SEWAGE DISPOSAL SYSTEM

MARYLAND STATE DEPARTMENT OF HEALTH

HOWARD COUNTY

Repair Septic Easement for Existing House 14831 Triadelphia Road

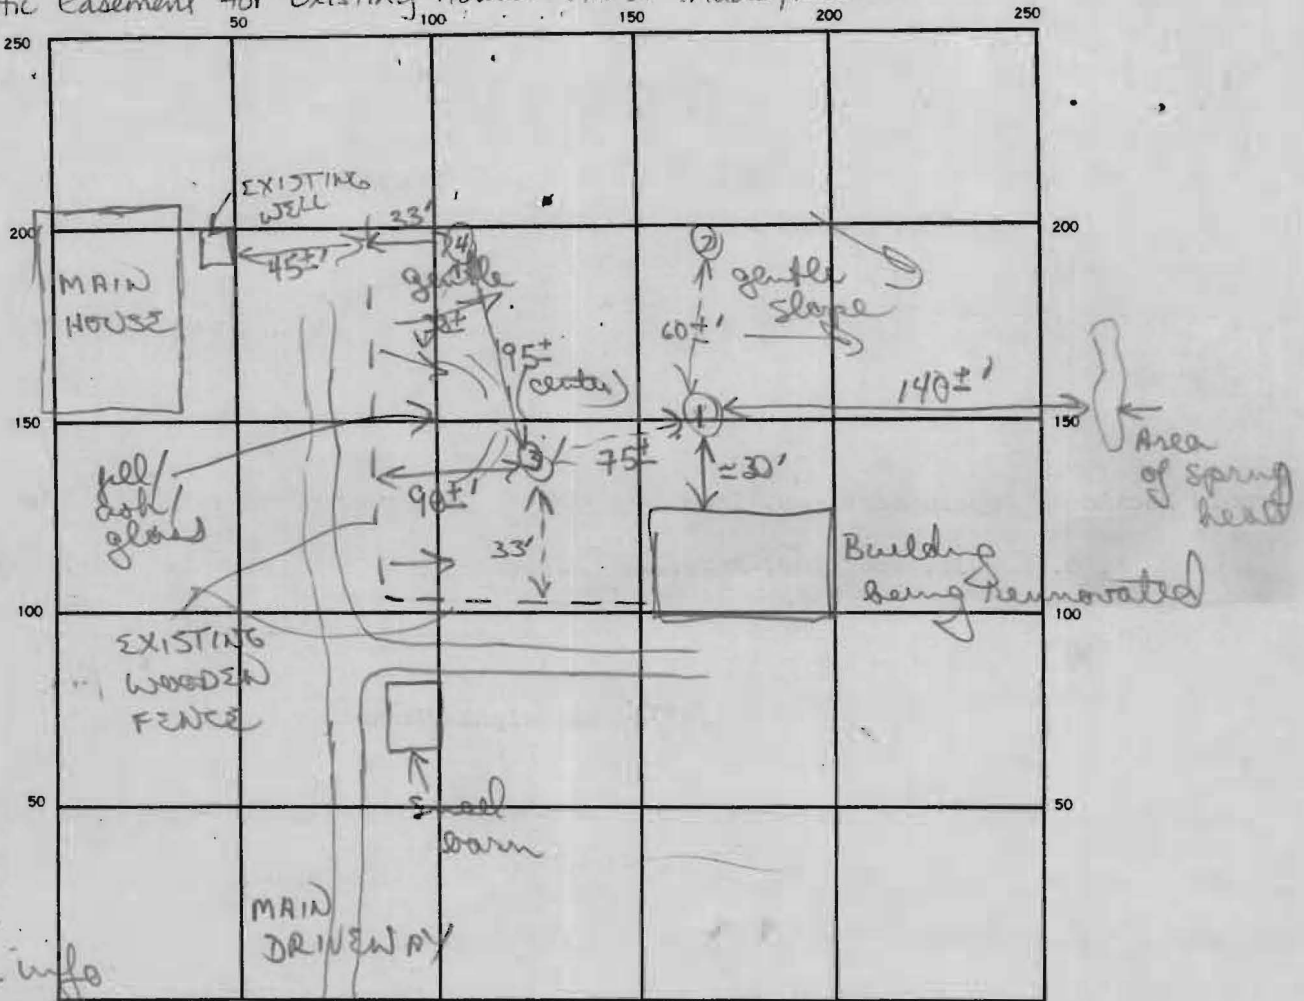
NOT A REPAIR TO EXISTING SYSTEM, BUT RATHER "RENOVATING"
AN EXISTING SHED LIKE BUILDING. THERE IS NOT APPARENT H₂O SUPPLY
DIRECTLY FEEDING SHED "REPAIR" TEST HOLE IN ONLY AREA FOR
GRAVITY HAD H₂O AT ' . ONLY AREA LEFT REQUIRES PUMP SYSTEM
